IREDELL COUNTY HEALTH DEPARTMENT

SEPTIC IMPROVEMENT PERMIT / AUTHORIZATION TO CONSTRUCT / OPERATION PERMIT / EXISTING SYSTEM

SITE ADDRESS: 130 Sierra Chase Drive Statesville NC 28677 PHONE: 704-944-5557 ALT. PHONE 704-578-4951 Kathleen Sanders

SUBDIVISION: Autumn Brooke SECTION: 2 LOT # 25 LOT AREA: 1/8 DESIGN FLOW: 360 gpd L.T.A.R.: .275 (.25) Reduction

INITIAL SITE SKETCH

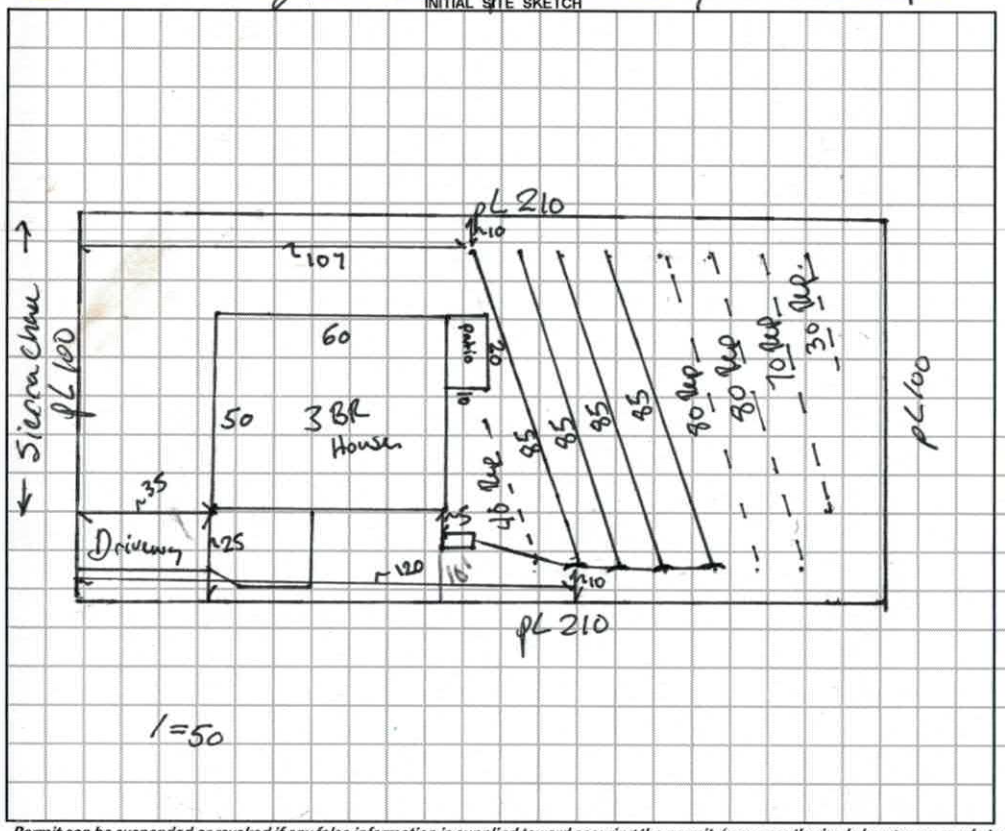
Comments / Conditions: Purpose of this permit is a Redraw due to house design change with patio. No offset from Drainfield to Patio. Remove berms See attached design dated July 26, 2018 by The Odom Group.
